REMARKS

This reply is submitted in response to the Office Action of July 14, 2004. The amendments above and remarks that follow address the points raised in the Office Action, and thereby, place this application in condition for allowance.

AMENDMENTS TO THE DRAWINGS

The attached sheets of drawings includes changes to Figs. 1-8.

Figure 1

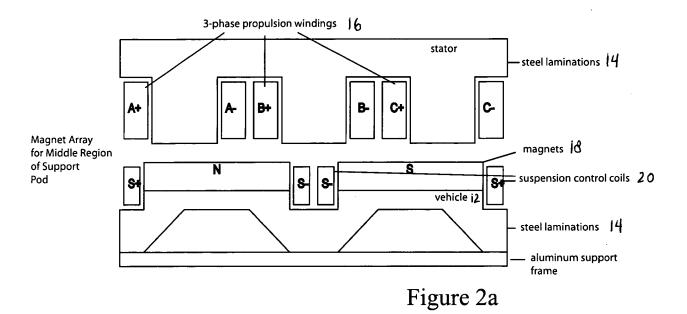
--Figure 1 shows a cross-section of the baseline suspension design <u>10</u> in a system according to the invention. The vehicle <u>12</u> is supported by a string of magnets <u>18</u> on each side and these magnets create attractive forces to the laminated steel rails <u>14</u> on the guideway <u>24</u>. <u>Also shown is box beam 22</u>. The dimensions shown in Fig. 1 were chosen with several factors in mind, e g.,--

Figure 2b

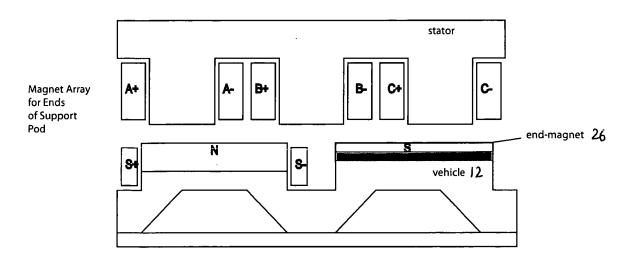
--In Fig. 2b, the end magnets <u>26</u> are not full height and do not have control coils. The reduced height reduces the attractive force when the magnet gap is small and this reduces the peak current required in the control coils. In some embodiments, a control coil is placed around the end magnets. A design of the end magnets could be quite different if the magnet array is very short or if higher suspension force is required, and such is envisioned herein.--

Figure 3

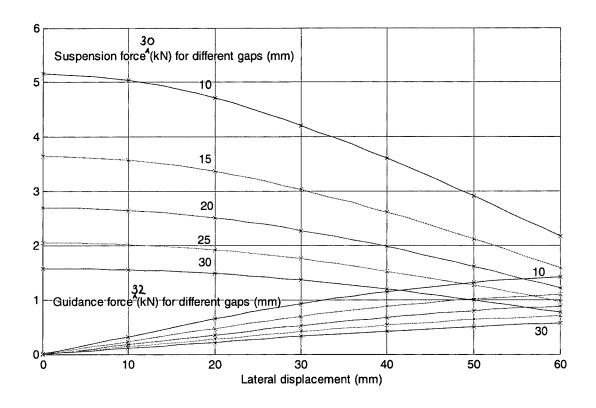
--Figure 3 is a graph depicting the suspension force 30 and guidance force 32 as a function of lateral displacement for a 1-wavelength (0.5 meter) section of vehicle magnets and for an 80 mm rail width, for a system such as described above. This graph was generated for magnets with an energy product of 40 mega Gauss Oersted (MGO) using 3D finite element analysis with periodic boundary conditions. The normal operation is with 20 mm vertical displacement and zero horizontal displacement and then the suspension force is 2,700 N per wavelength, as shown in the graph. The suspension will then support 550 kg of mass per meter of length of the magnet pods. The 2 half-magnets on the ends of the pods will produce additional lift of 630 N total for magnets with the dimensions and locations shown in Fig. 2b. Four pods, each with a length of 3 meters, will then lift 6,700 kg, the approximate mass of a normally loaded (i.e. 75% of the seats filled), small bus size vehicle.--

Figure 4

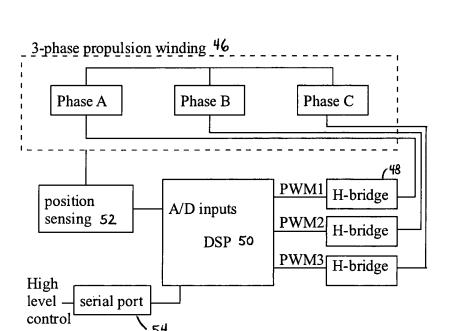
--The relative dimensions shown in Fig. 2b were chosen according to this criterion. A magnet pod <u>40</u> with four full magnets <u>42</u> and the two end magnets <u>44</u> is shown in Fig. 4.—

Figure 7

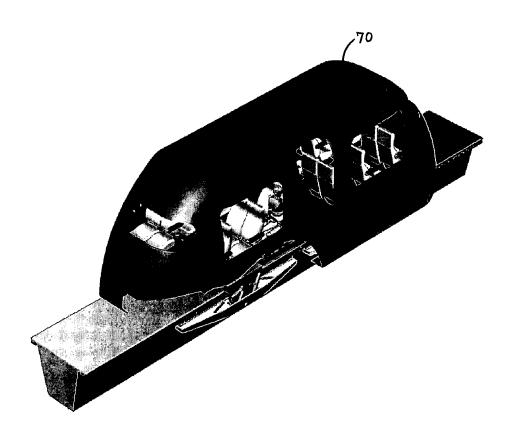
--Fig. 7 depicts a vehicle 70 according to the invention with four pods that pivot in two dimensions in order to allow negotiating horizontal and vertical turns. Fig. 8 shows how the magnet pods, such as those illustrated in Fig. 7, can be attached to a vehicle 80 according to the invention. Fig. 8 also shows optional mechanical mechanisms according to the invention that damp oscillations of the pods with respect to the vehicle.--
